The Sandstone Precinct: MOD 7 Design Report

Document Number
SP-RPT-E-MAKE-0005

MOD 7 Design Report

Sixth floor level

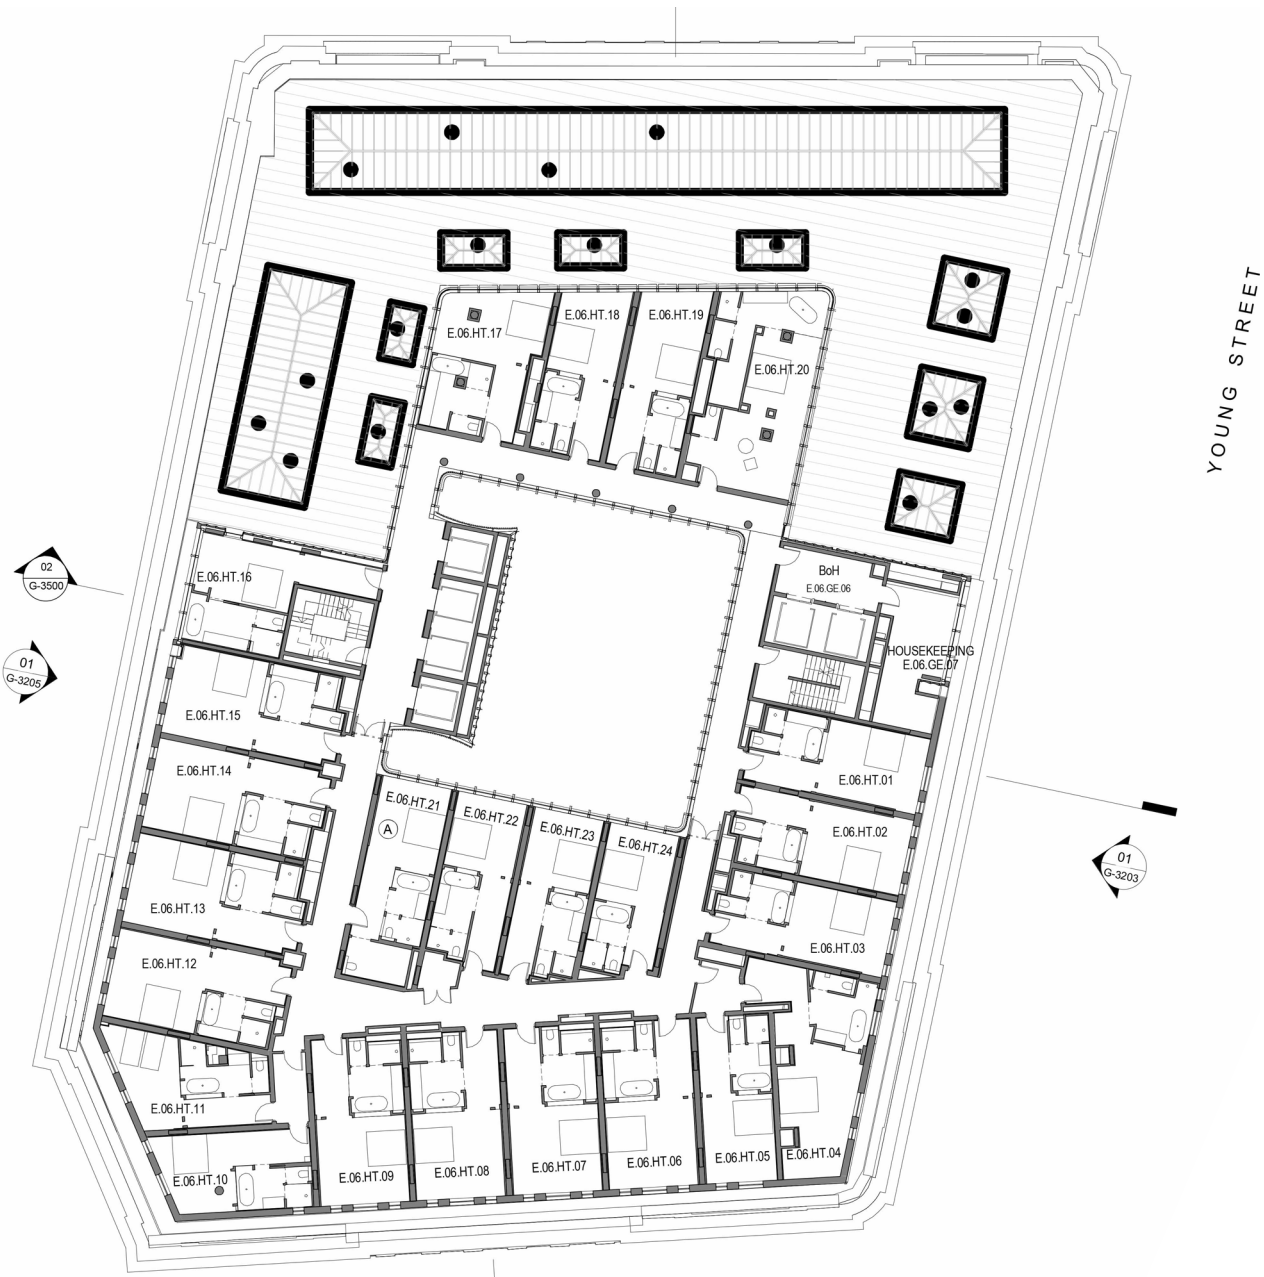
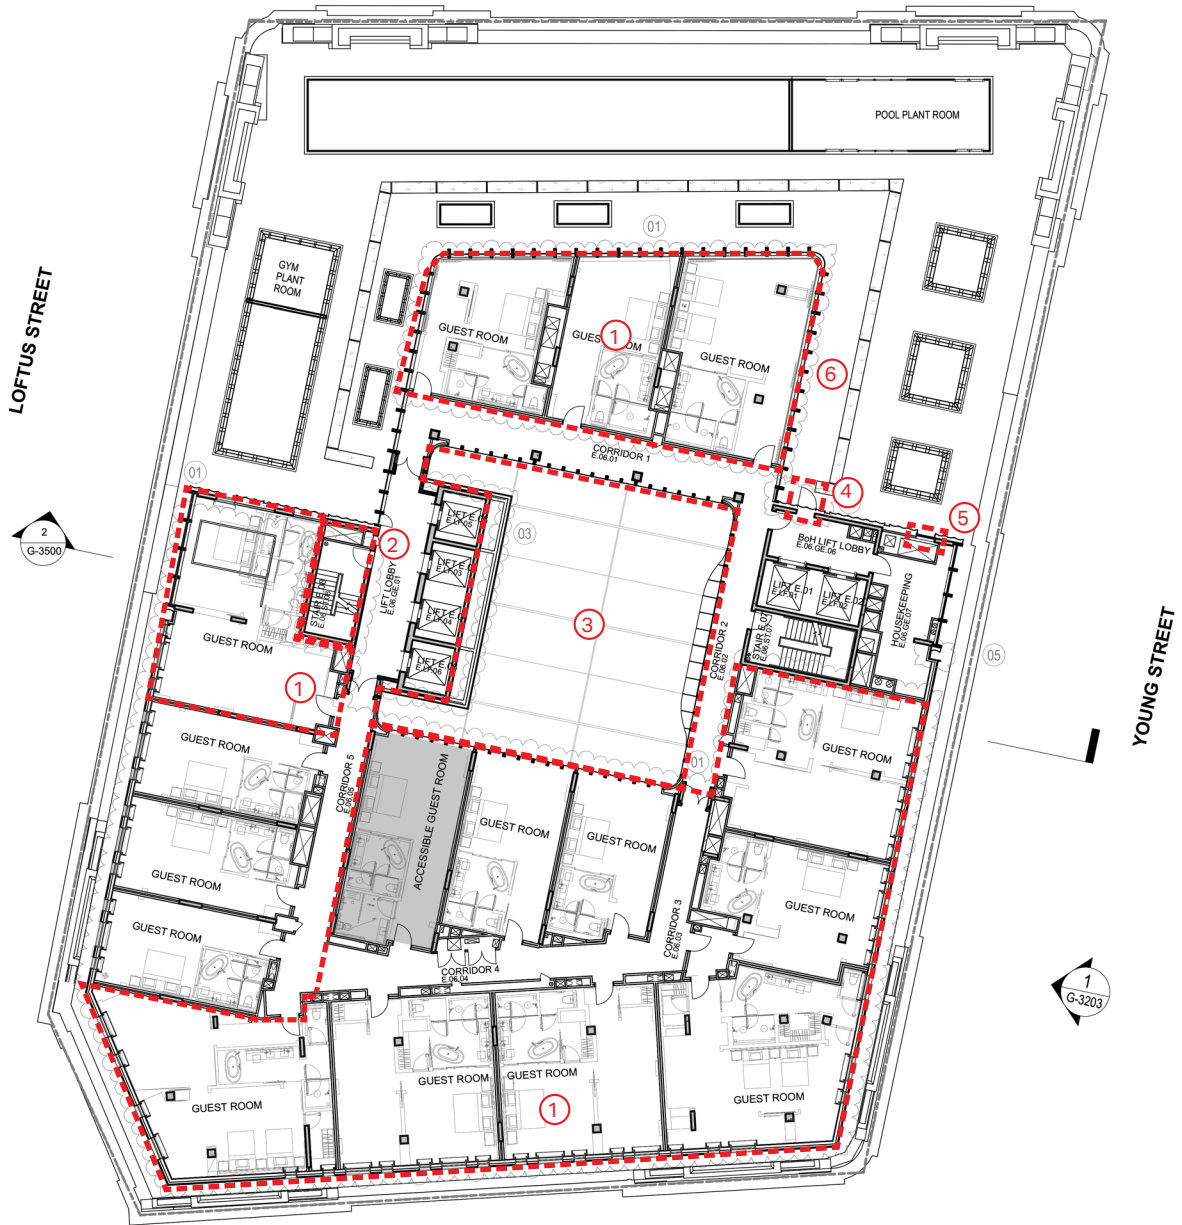
- Notes**
1. Reconfiguration of northern, southern, courtyard and west tower guest rooms resulting in reduction of keys
 2. Stair E.08 reconfigured
 3. Courtyard facade design updated to accommodate reduction in number of courtyard guest-rooms (from 4 to 3). Fluted lift core cladding changed to flat panel cladding.
 4. Concealed maintenance door added.
 5. Addition of architectural louvre with weatherproof mechanical air intake louvre behind
 6. Accessible landscaped guest terrace deleted. Roof becomes maintenance access only.

Initial substation proposal

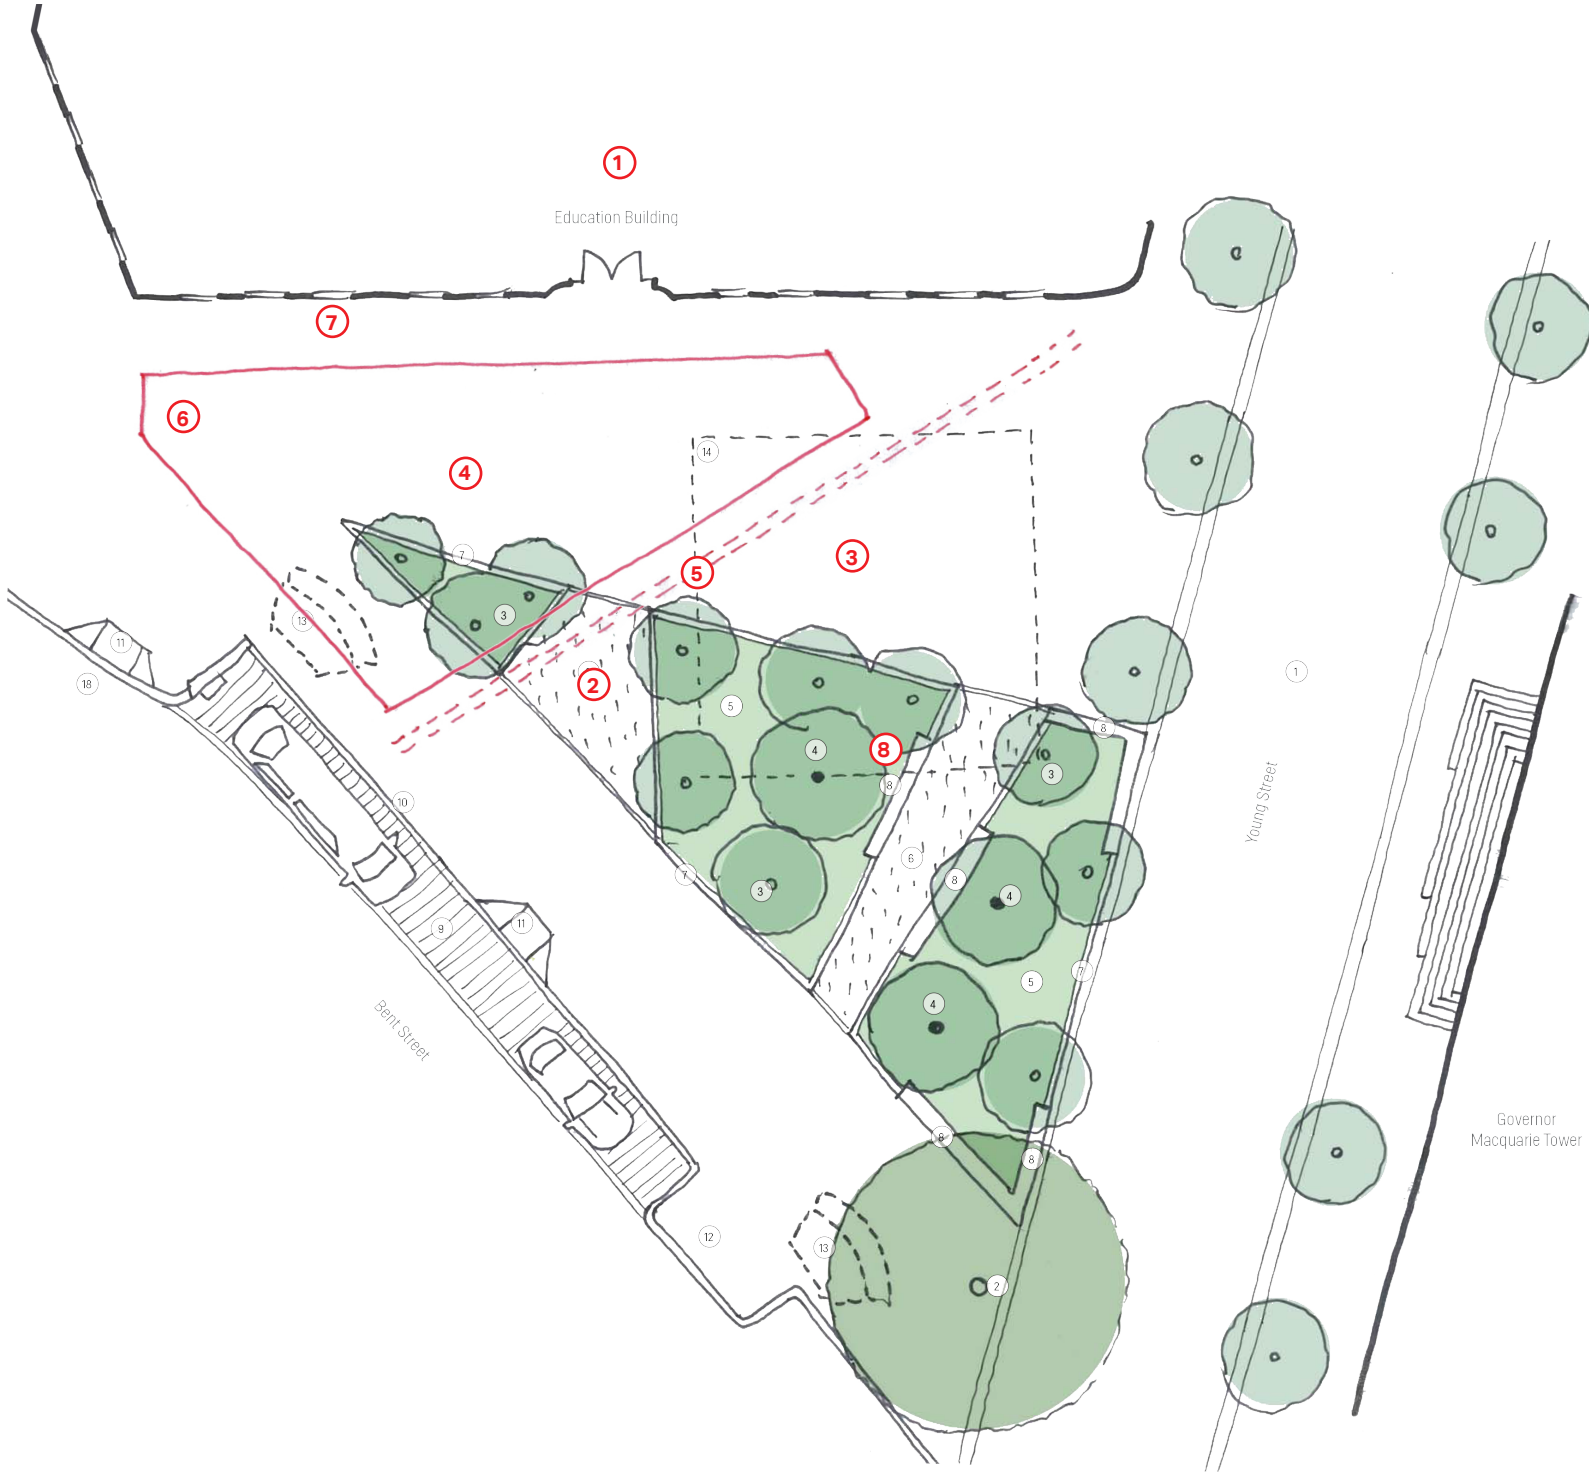
- Conditions
- 1. Education Building
 - 2. Farrer Place landscape design by Aspect Studio
 - 3. Existing substation
 - 4. Proposed substation
 - 5. Existing sewer line

- Rejected by Ausgrid due to:
- 6. Access through hatch at street level
 - 7. Substation air intake through education building moat at street level
 - 8. Substation air exhaust through integrated seating into Farrer Place landscape

Substation proposal

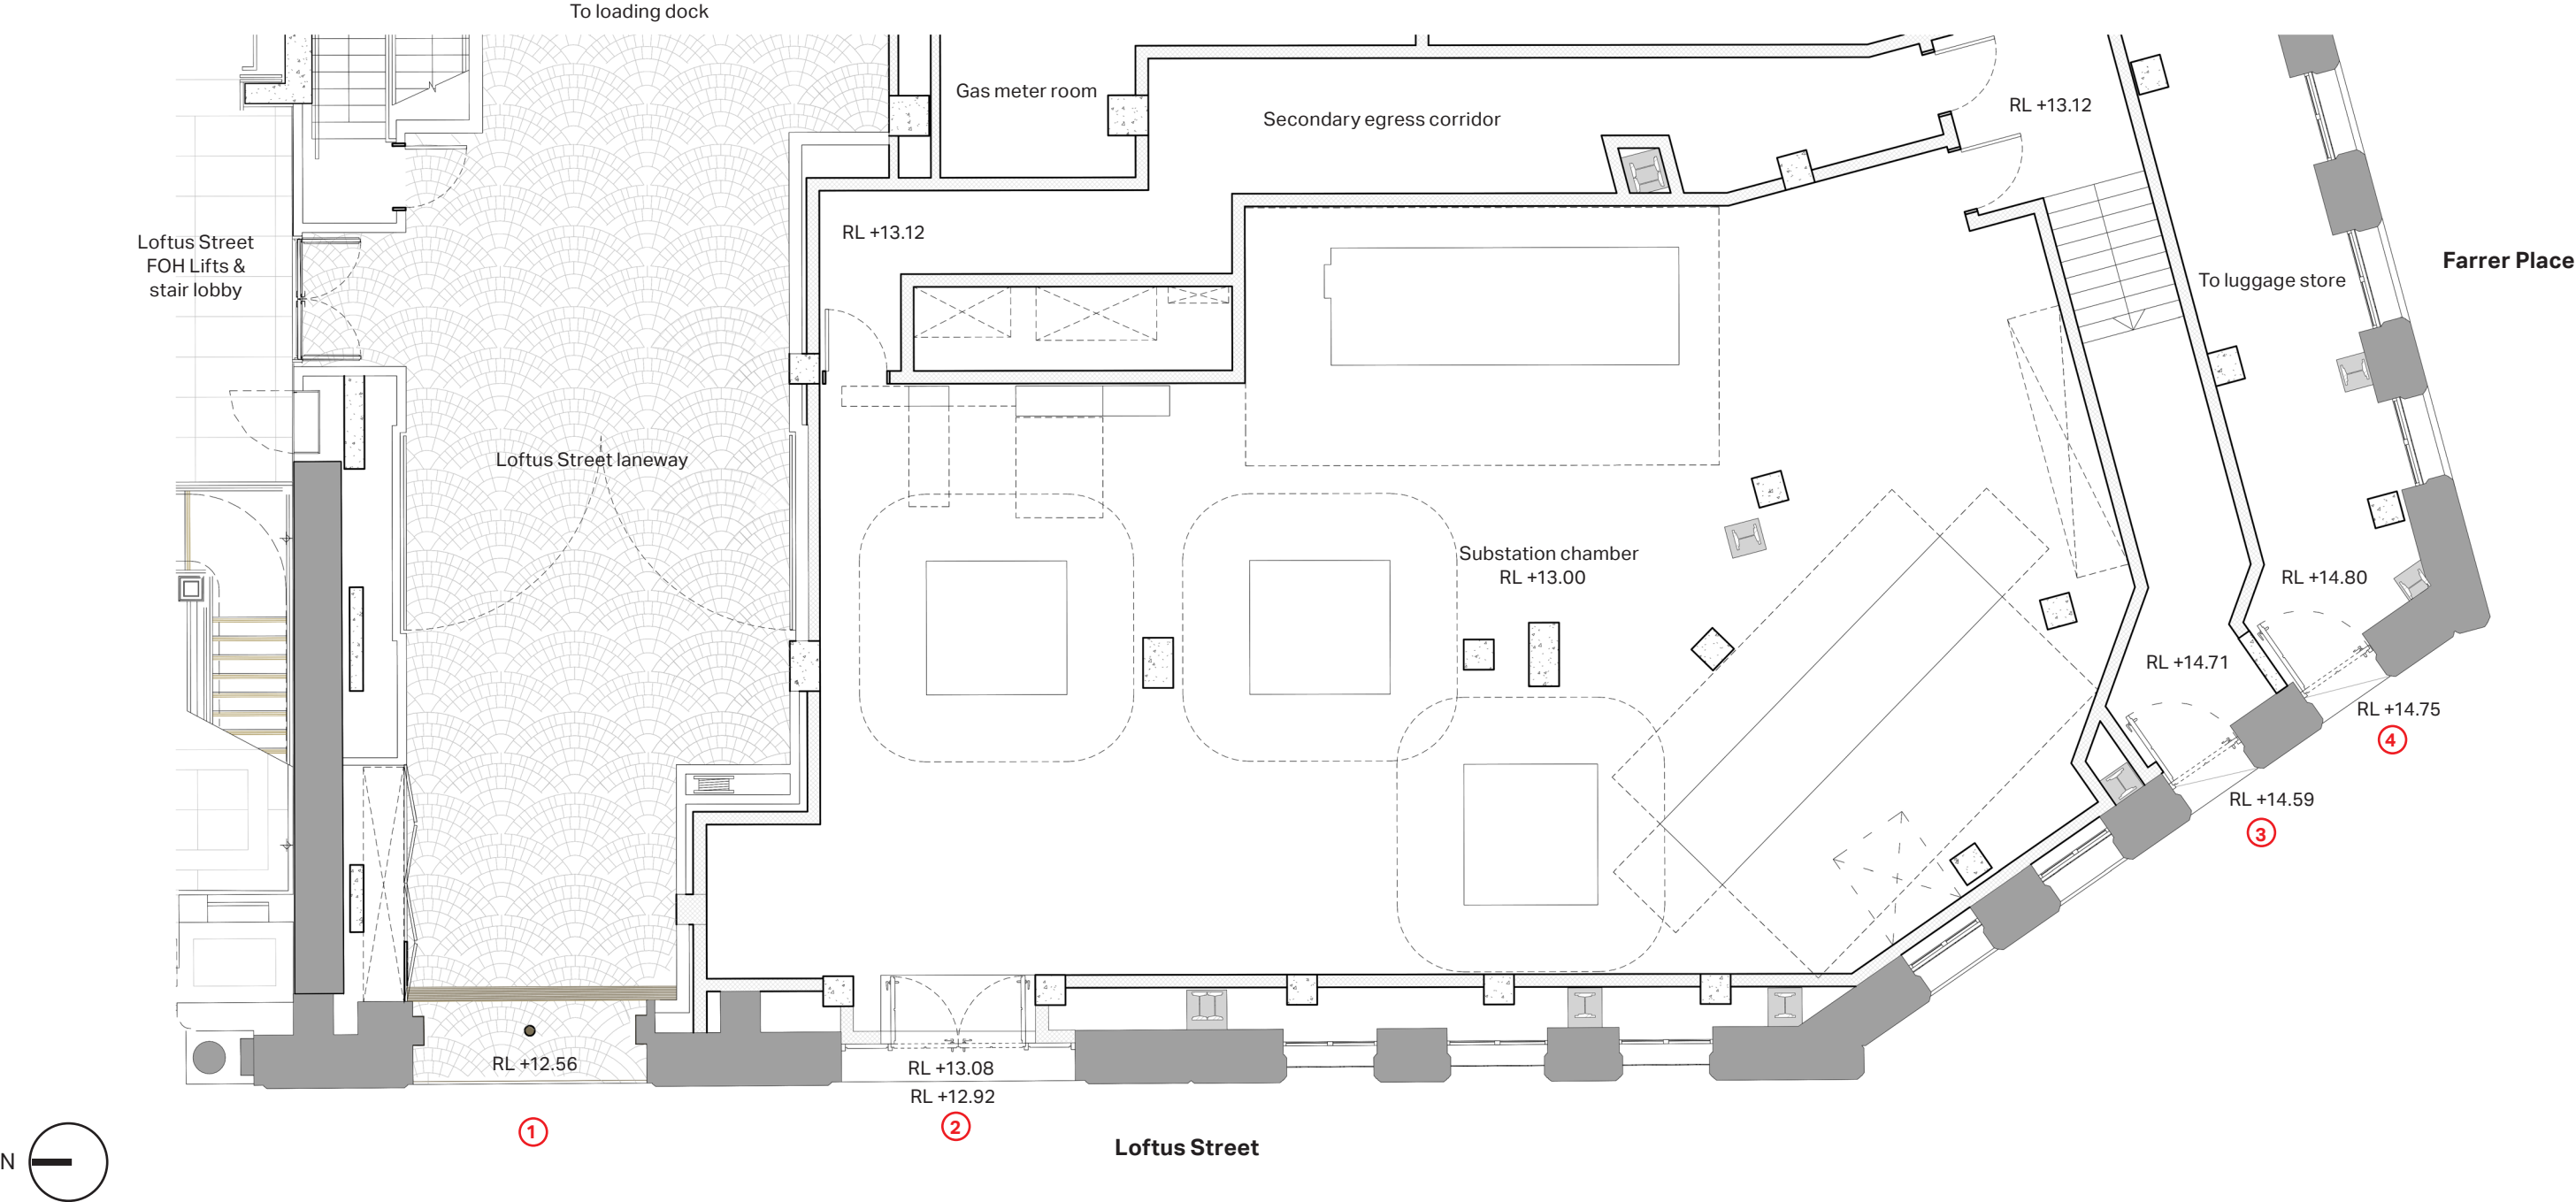
The proposal relocates the substation from Farrer Place to inside the building and replaces the destination bar at lower ground.

- 1. Existing arched opening through to Loftus Street laneway- DDA entrance (Guest and staff access)
- 2. Substation equipment door (Ausgrid access only)
- 3. Entry door to substation chamber (Ausgrid access only)
- 4. Entry door to luggage store (Staff access only)
